FIRE SAFETY INSPECTION REPORT

**LIBERTY KNITWEAR LTD.
RAMARBAGH, KUTUBPUR, FATULLAH,
NARAYANGONJ**

ACCORD
on Fire and Building Safety in Bangladesh

April 10, 2014

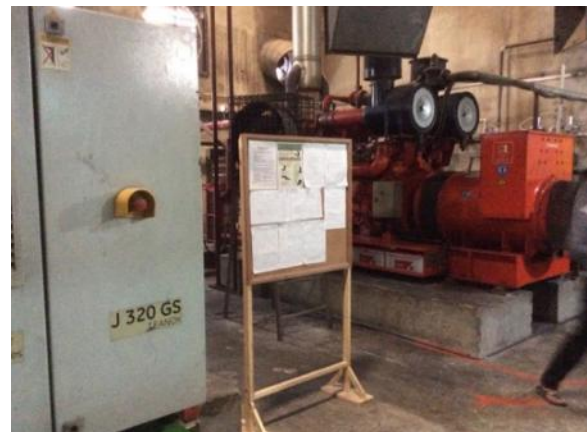
No.	Category	Finding	Recommendation	Remediation Timeframe
F-1	Fire Rated Construction	The generator room is not separated by fire-rated construction and openings, non-rated doors, penetrations.	Separate the generator room by a minimum 2-hr fire-rated construction. Seal and protected all openings to maintain the required fire separations	Within 3 months

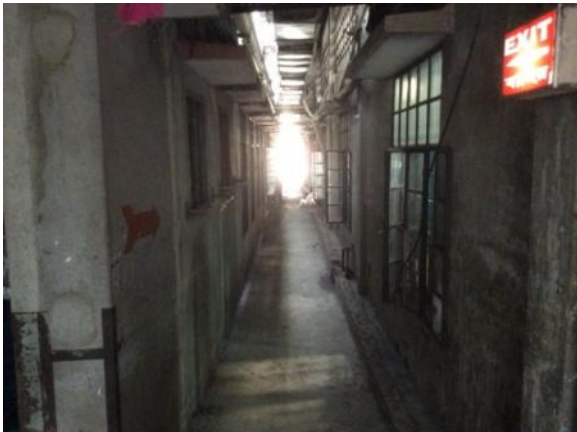
F-7 Egress

Exit discharge area is not separated by fire-rated construction.

Separate the exit discharge areas by a minimum 2-hr fire-rated construction. Seal and or protected all openings to maintain the required fire separations
